Memorandum

TO: District of Columbia Zoning Commission

SUBJECT: FMBZA 19013 –Application of the Apostolic Nuncio of the Holy See, pursuant to 11DCMR § 1002 and §206 of the Foreign Missions Act

Attachment III – Simulated Sketches

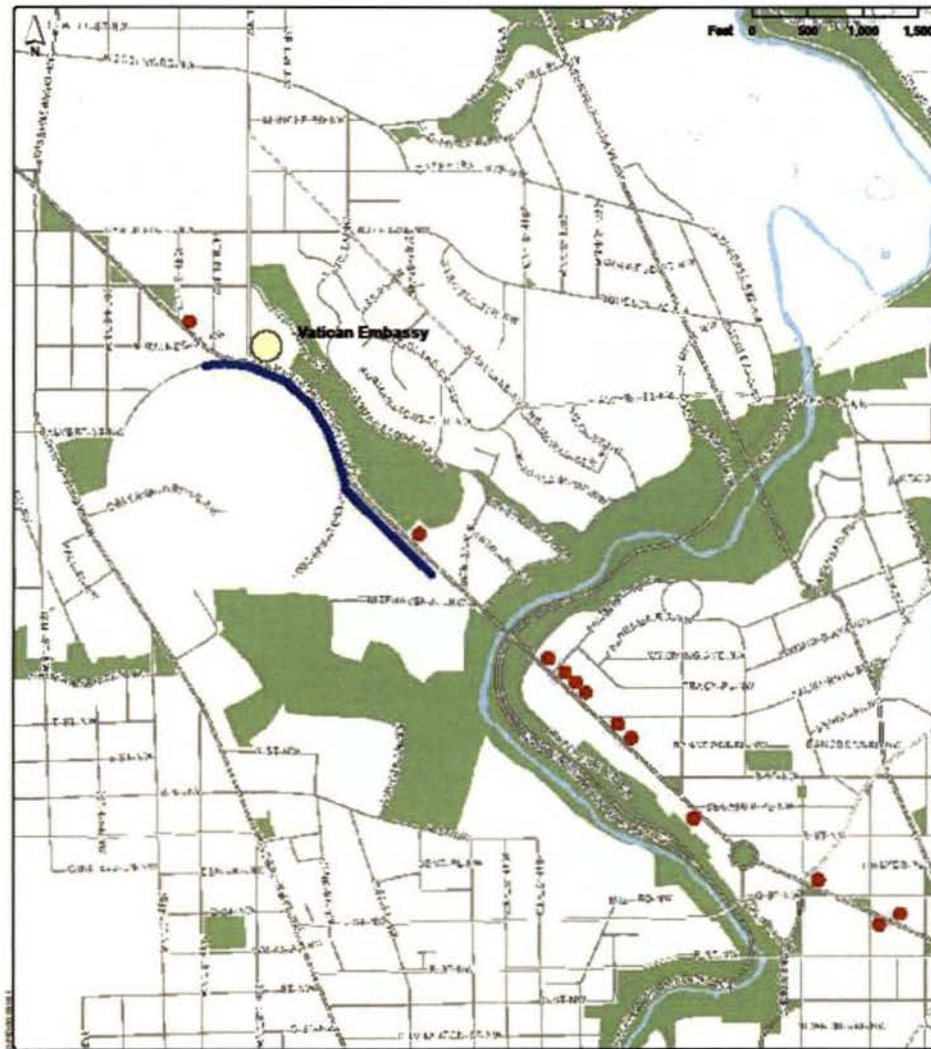
located three feet from the back of the sidewalk, behind hedges, and within a building restriction area. Along Massachusetts Avenue, the fence is proposed to be in public space. The fence's visual impact along Massachusetts Avenue, where the embassy is set back more than 80 feet from the curb, is notable. In this location, the fence impacts the view corridor along the Avenue, where it is proposed to be eighteen inches from the back of the sidewalk. While the fence along 34th Street also requires a waiver from regulations, its location behind landscaping mitigates its impact on public space.

The Department of Transportation's Urban Forestry Administration reviewed the application and recommends that, to ensure the health of the trees in public space, the fence along Massachusetts Avenue should be relocated as far from existing trees as possible, a location that is more consistent with the one being recommended by the Office of Planning.

The Office of Planning, therefore, has no concerns with the proposed design, materials, or height of the proposed security fence and gates, but concludes that it would be made more consistent with District interests in maintaining the open character along Massachusetts Avenue and maintaining the health of street trees by placing the fence up to 38 feet back from the curb. This would also satisfy U.S. Department of Homeland Security criteria and embassy needs for the standard 50 foot security buffer between the fence and the building.
